Wollongong Local Planning Panel Assessment Report | 24 September 2020

WLPP No.	Item No. 4
DA No.	DA-2019/1273
Proposal	Subdivision - Torrens title - two (2) existing lots into three (3) lots and construction and use of a food and drink premises, service station, centre based childcare facility and two (2) commercial tenancies.
Property	1 Raven Street, WONGAWILLI NSW 2530 - Lot 336 DP 1241313 9 Raven Street, WONGAWILLI NSW 2530 - Lot 337 DP 1241313
Applicant	The Stevens Group
Responsible Team	Development Assessment and Certification – City Wide Team (MB)

ASSESSMENT REPORT AND RECOMMENDATION

Figure 3. Location of the buildings in relation to site as a whole.

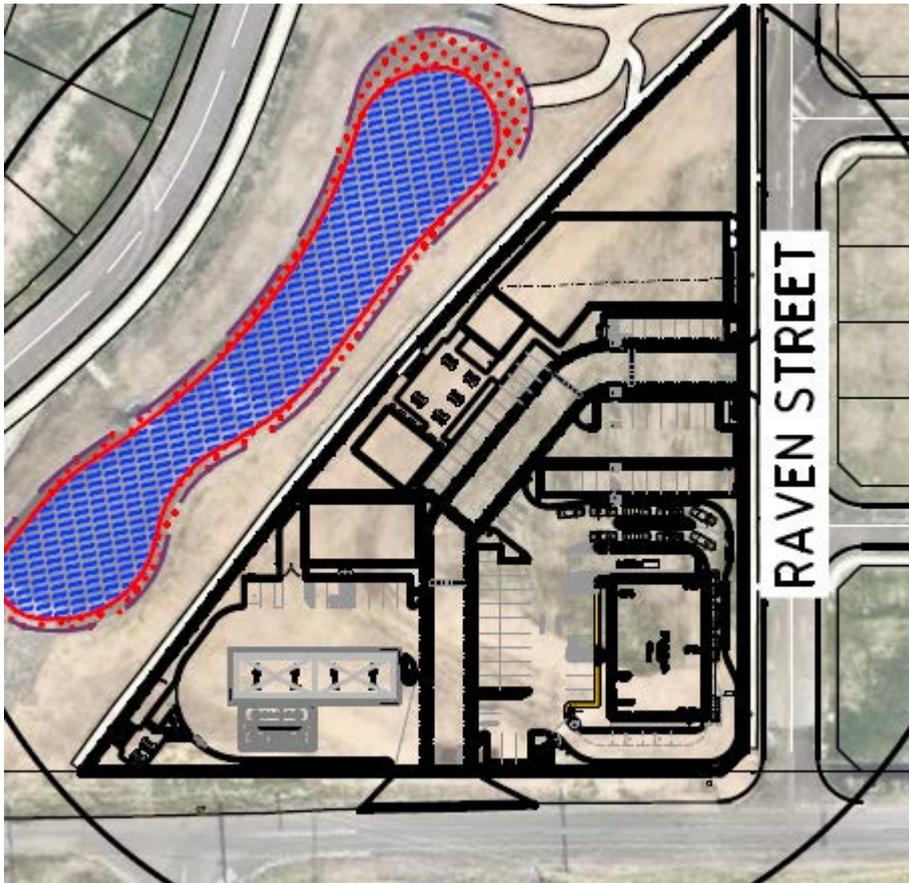
A portion of the commercial development is shown on plans to encroach into the R2 zone, which is prohibited unless consideration is requested to utilise Clause 5.3 – Development on zone boundaries.

A portion of the commercial development is shown on plans to encroach into the R2 zone, which is prohibited unless consideration is sought under this clause.
